WPX Energy
Plug & Abandon Procedure
December 20, 2016

Well:	Rosa #403	API:	30-039-30901
Location:	2265'FNL & 320'FEL	Field:	
Sec, T, R:	Sec. 14, T31N, R5W	Elevation:	6501' GR
Cnty/State:	Rio Arriba, New Mexico	By:	Aztec Well Servicing
Lat/Long:	36.900444, -107.3236389

ROSA UNIT #403
FRUITLAND COAL
Proposed P&A

Re: Permanent Abandonment
Well: Rosa Unit #403

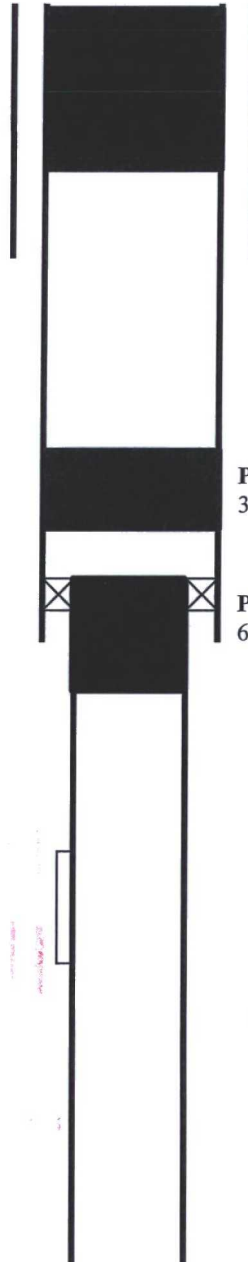
- a) Add Plug from (2734'-2634') ft. to cover the Ojo Alamo top. BLM picks top Ojo Alamo at 2684' ft.
- b) Add plug from (1407'-1307') ft. to cover Nacimiento top. BLM picks top of Nacimiento at 1357' ft.
